Access Compliance Report

Public Rights-of-Way

(Curb Ramps)

Intersection ID: 44473	Main Street: AMES_HOLLOW_RD	Cross Street: COREY_COMMON_AV	Location: NW
ADA ID: 465EE7C5A336	Ramp Type: PerpDiag	Initial Pass/Fail: Fail	Overall Compliance: No
Severity Score: 8.75			
Codes/Mitigation Info/Possible Solution		Field Measurements/Component Compliance

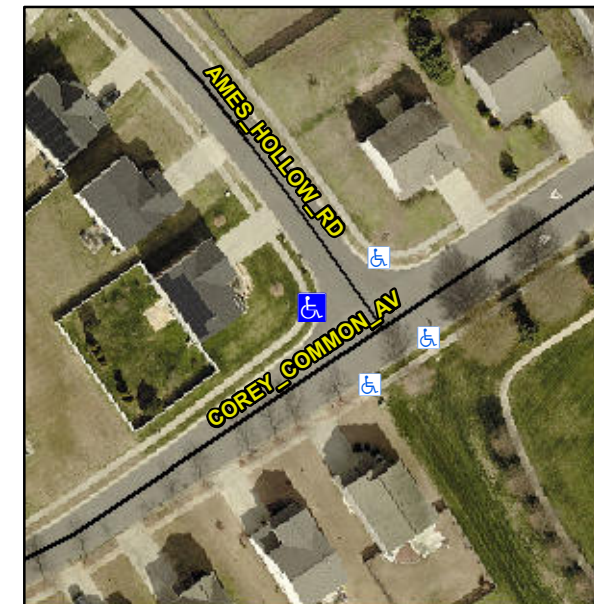
Not Found, R304.5.1

Remove & Replace Curb Ramp With Two New Directional Ramps or Equivalent.
